| Project: | PROPOSED POOL, SPA & ALFRESCO |
| Site: | 35 KEEL RETREAT, PORT GEOGRAPHE |

| Sheet title | **FLOOR PLAN** |

**A3-01**

# FLOOR PLAN

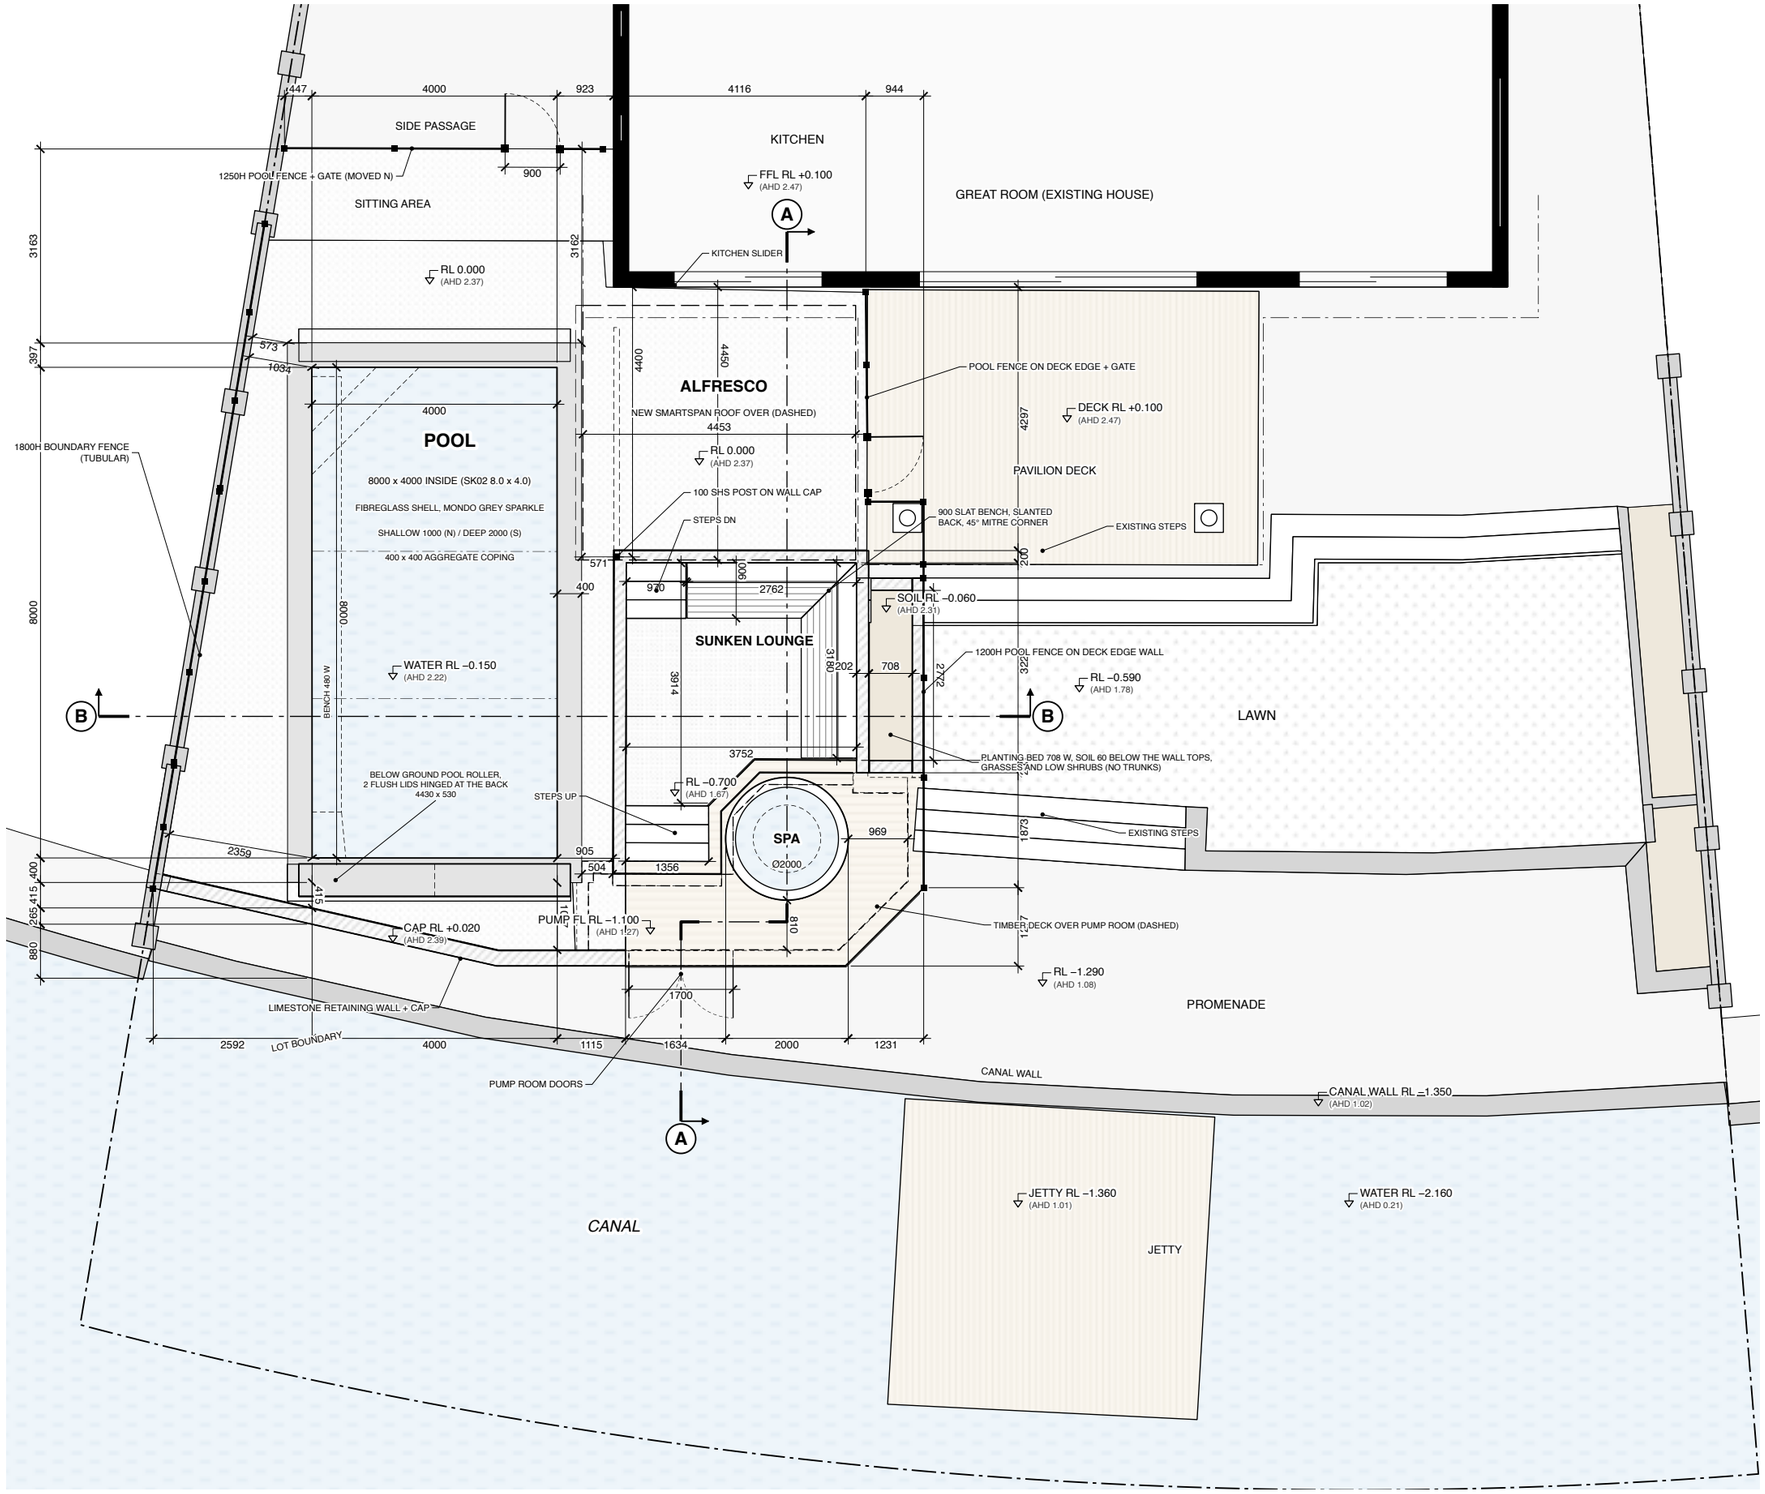
- B3 at its north end: only about 1440 above the existing lawn steps against it. OK as is?
- Pump room doors in B4, the canal-side barrier wall: their outside face must be non-climbable. Which door and finish?
- B1 and B3 stop 170 and 90 short of the house wall: close them up.
